# JR. HIGH RENOVATION FACILITY ANALYSIS

## GUTHRIE PUBLIC SCHOOLS

November 19, 2013

Re: Guthrie Junior High Initial Scope Visit  
Wallace Engineering Project Number 1311059

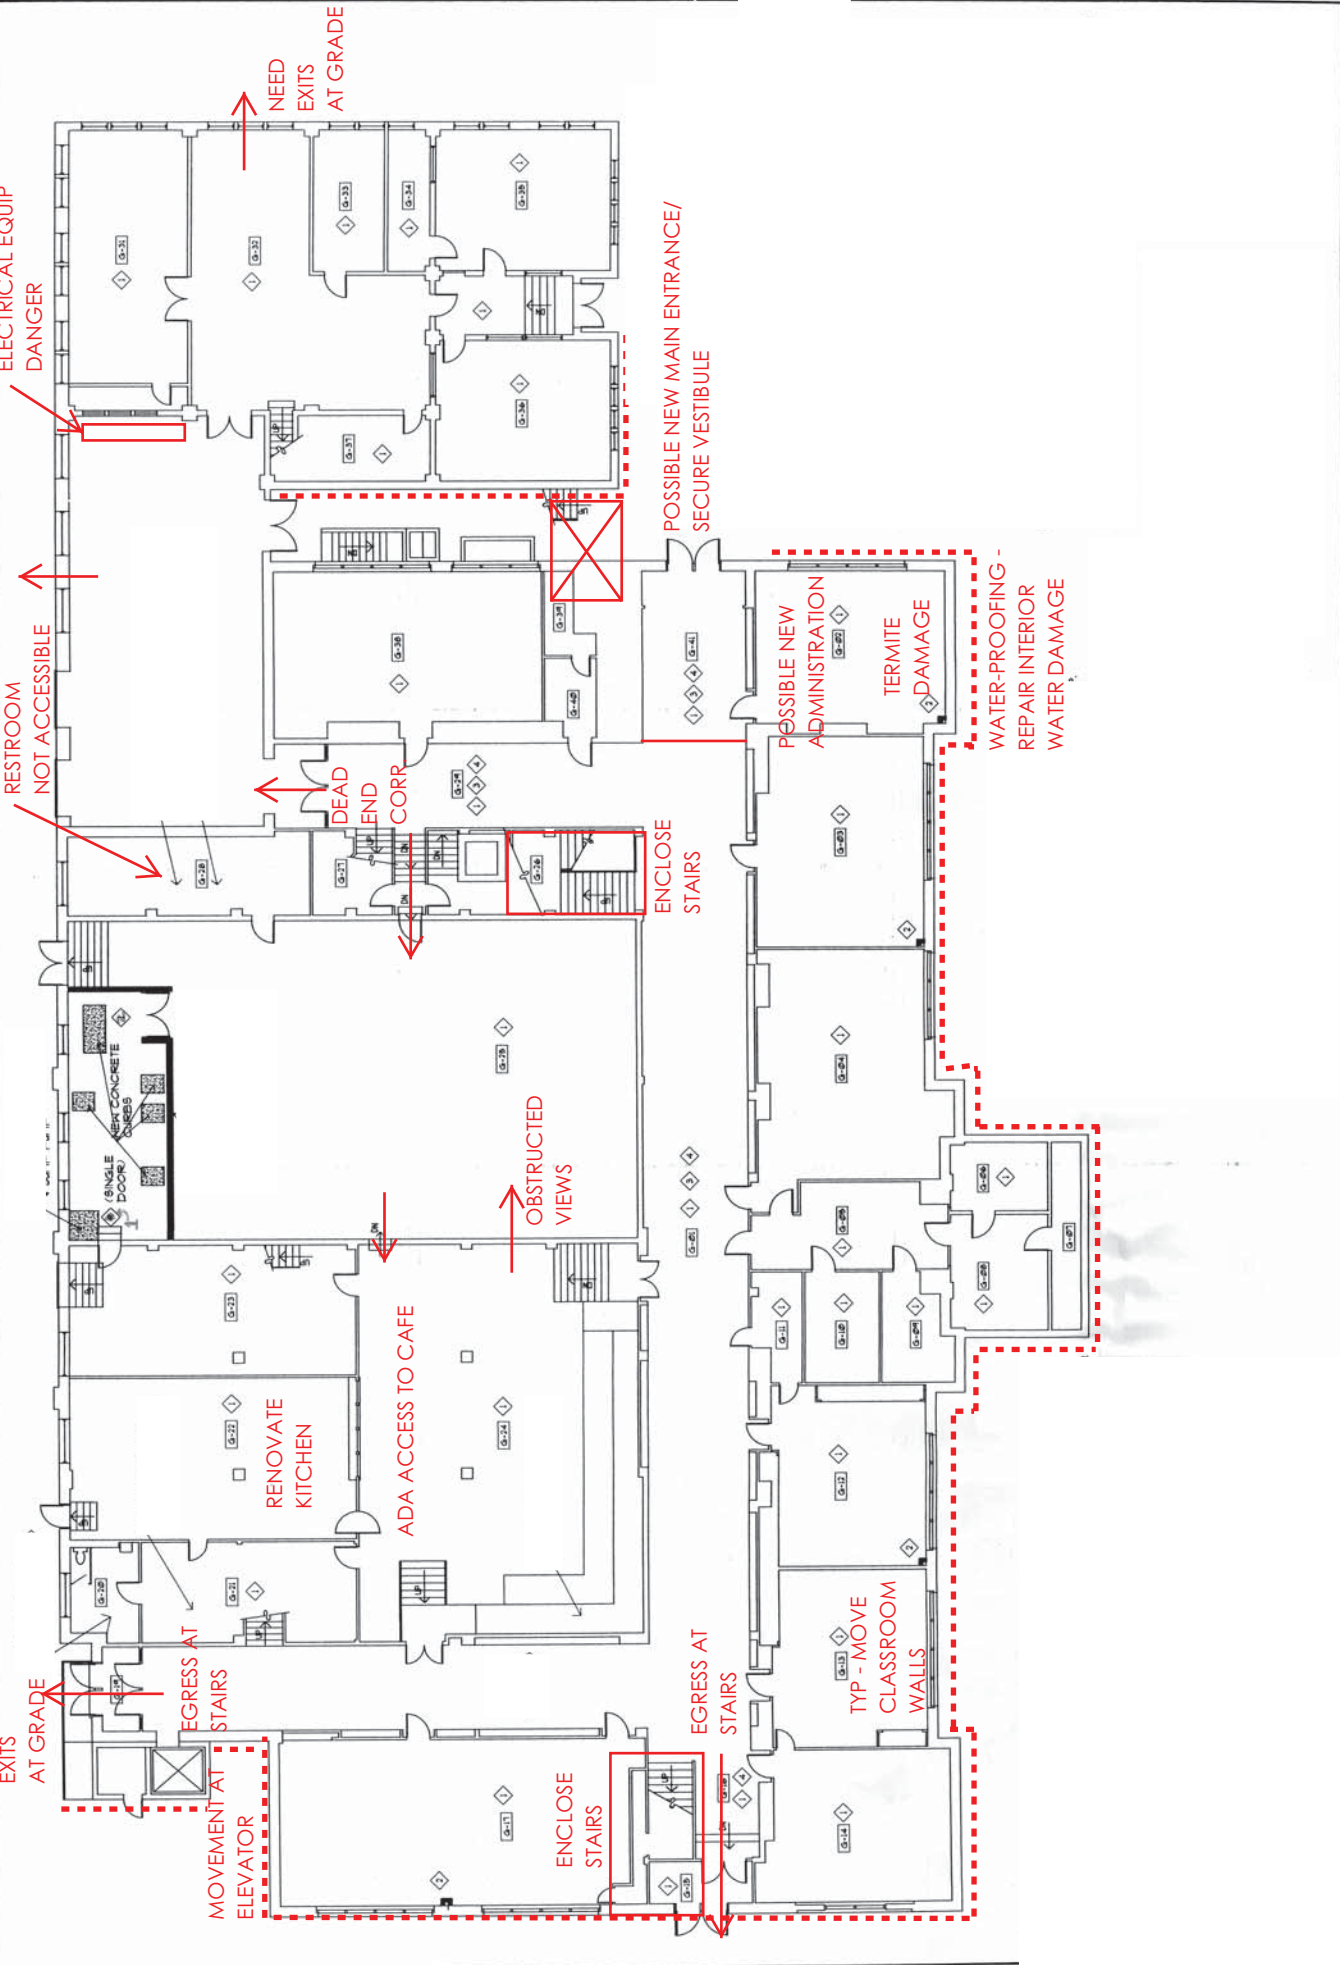
NEED EXITS AT GRADE

NEED EXITS AT GRADE

NEED EXITS AT GRADE

ELECTRICAL EQUIP DANGER

RESTROOM NOT ACCESSIBLE

MOVEMENT AT ELEVATOR

EGRESS AT STAIRS

ENCLOSE STAIRS

RENOVATE KITCHEN

ADA ACCESS TO CAFE

OBSTRUCTED VIEWS

ENCLOSE STAIRS

ENCLOSE STAIRS

EGRESS AT STAIRS

POSSIBLE NEW MAIN ENTRANCE/ SECURE VESTIBULE

POSSIBLE NEW ADMINISTRATION

TYP - MOVE CLASSROOM WALLS

**1 SECOND FLOOR PLAN**  
 1/8"=1'-0"

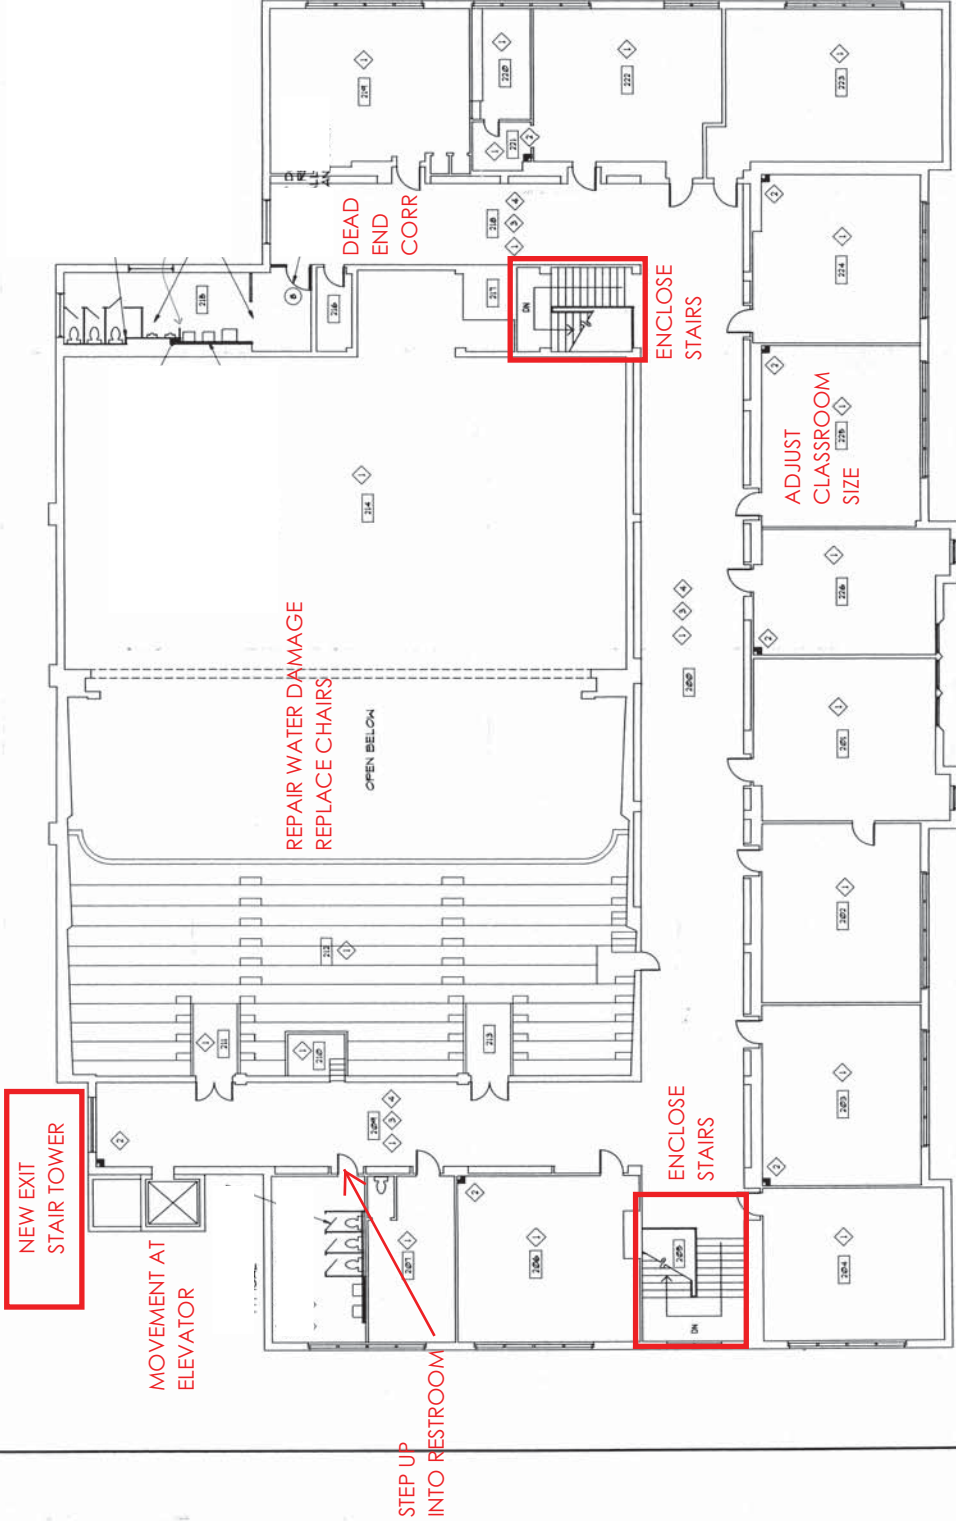
TERMITE DAMAGE

WATER-PROOFING - REPAIR INTERIOR WATER DAMAGE

NEED EXITS AT GRADE

NEW EXIT  
STAIR TOWER

MOVEMENT AT  
ELEVATOR

REPAIR WATER  
DAMAGE

ENCLOSE  
STAIR

NEW EXIT  
STAIR TOWER

ENCLOSE  
STAIR

SECURE  
WASTEBLE

WATER DAMAGE  
UNDER STAIRS

ADA RAMP TO ENTRY

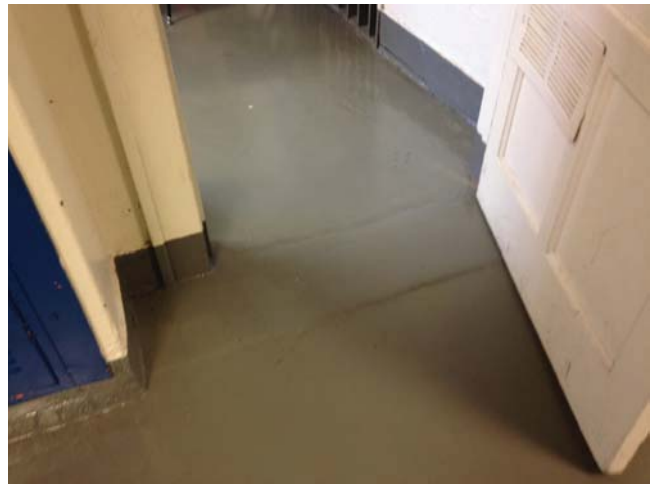
Termite Damage

Step down into classroom

Egress below grade

Step up into restroom—ADA upgrades

Movement at previous addition line

Renovate Auditorium

Water repair—new seating/ lighting

Heating/ seating/ lighting/ finishes

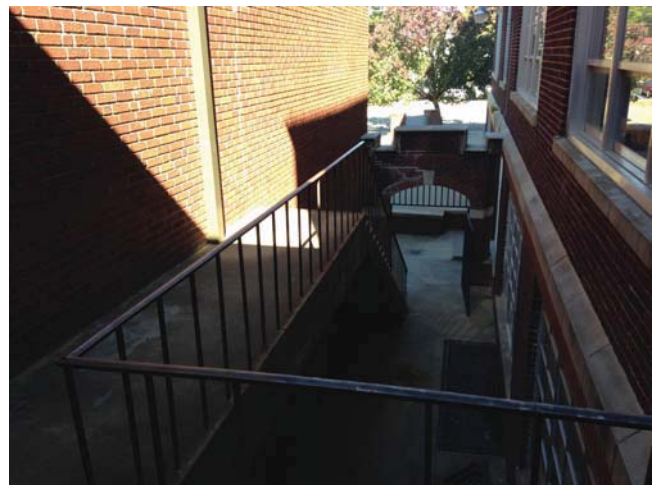
New lockers/ flooring/ finishes

Clean up exterior utilities/ alley access

Exterior needs tuckpointing

Egress stair not to code

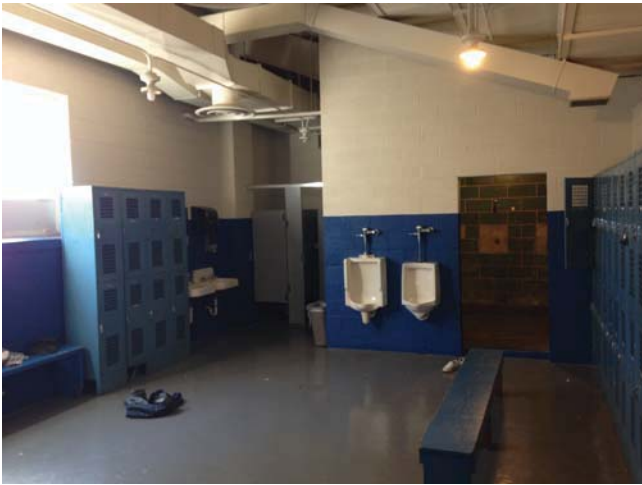
Locker rooms need full renovation

All windows should be replaced

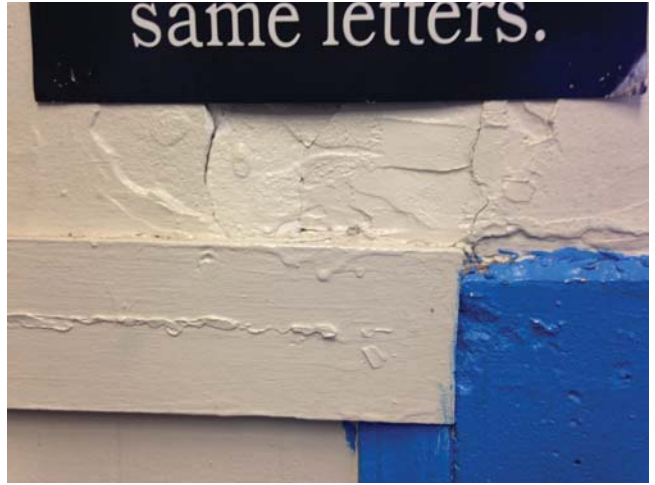
Café access difficult—poor visibility

Water damage below grade

Cooler/ freezer located outside

Kitchen needs reorganized/ updated

Some settling observed—easily corrected

Non-accessible egress path

Brick needs tuckpointing

Movement at elevator—new windows

Elevator—some movement

Gym exterior in better condition

Picture #1 – Water Damage at First Level

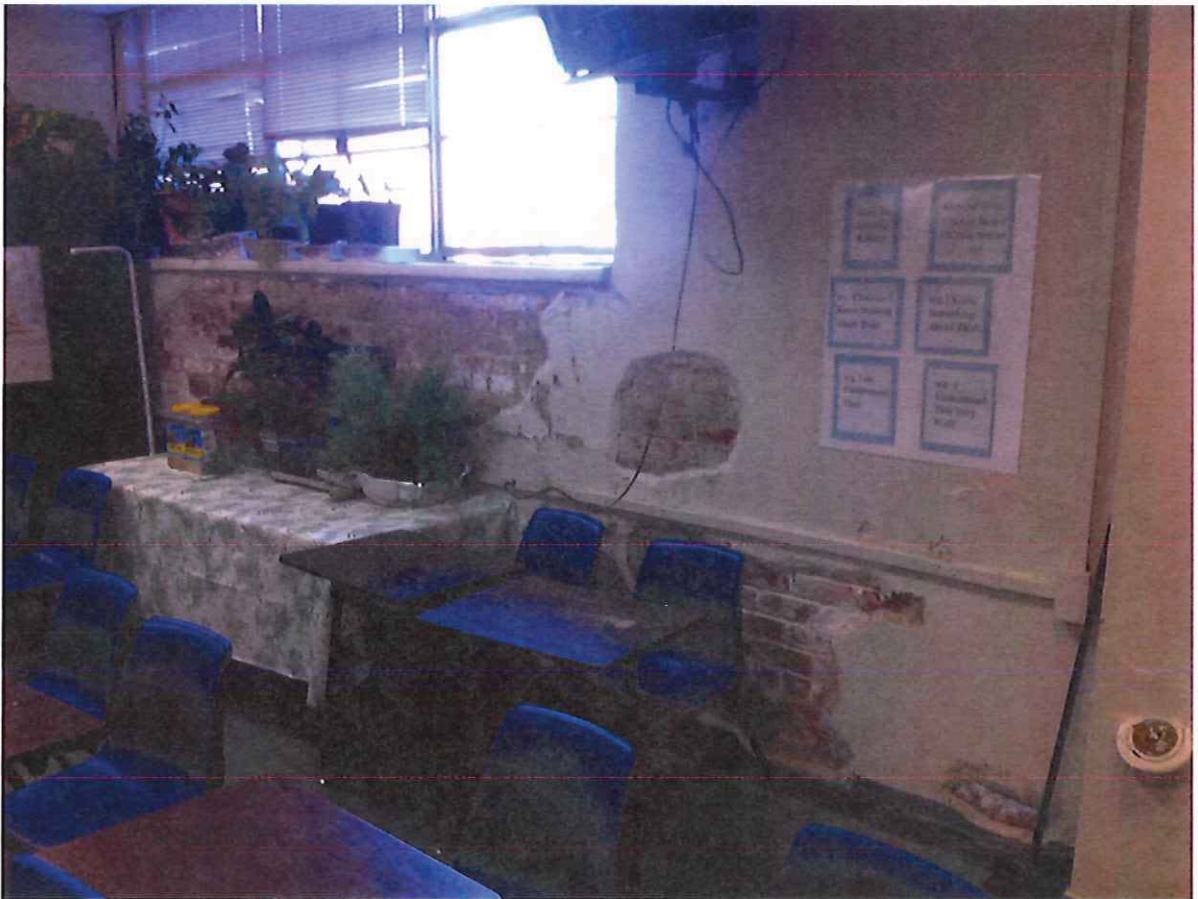
In several locations along the north wall at the first level, damage to the plaster finish and substrate has been caused by water infiltration. Pictures 1, 2 and 3.

Picture #8 – Separation of Elevator Shaft From Main Building

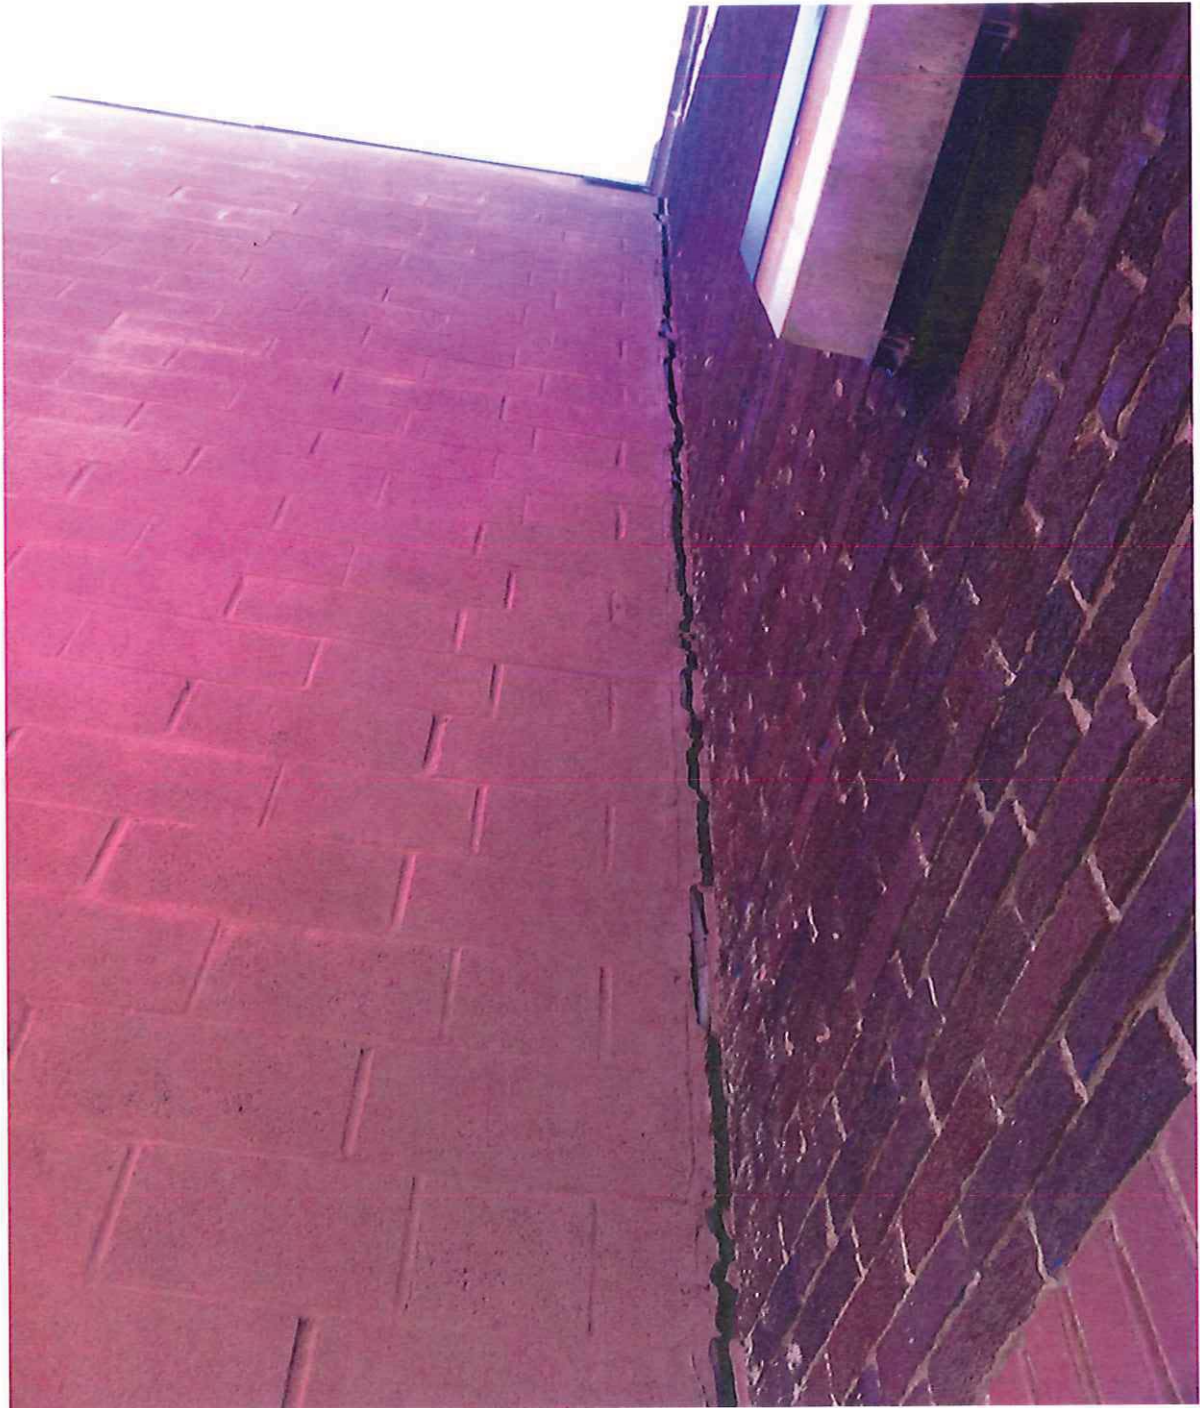
The elevator shaft addition has shifted away from the main building opening a joint of approximately  $\frac{3}{4}$ -inch at the second level and wider as it goes up to the roof. Pictures 6, 7 and 8.

Picture #9 – Water Damage to Plaster at Upper Level of Auditorium

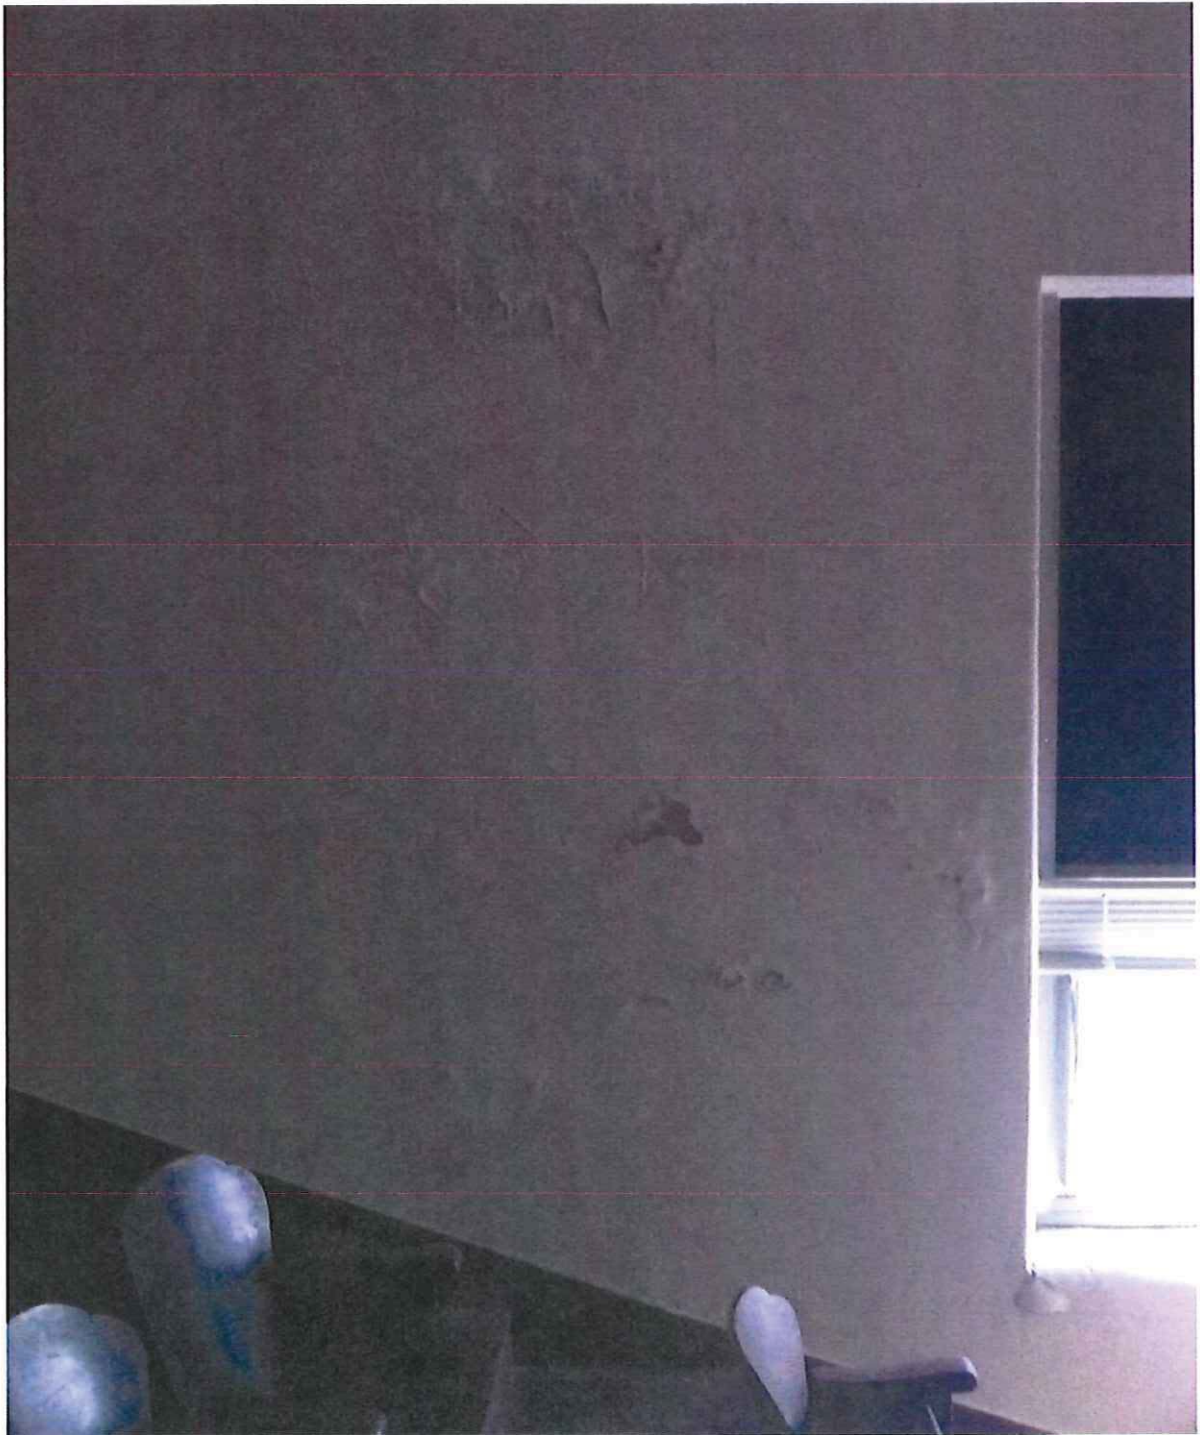
Water infiltration has damaged the plaster around one of the windows in the upper level of the auditorium. Pictures 9 and 10.
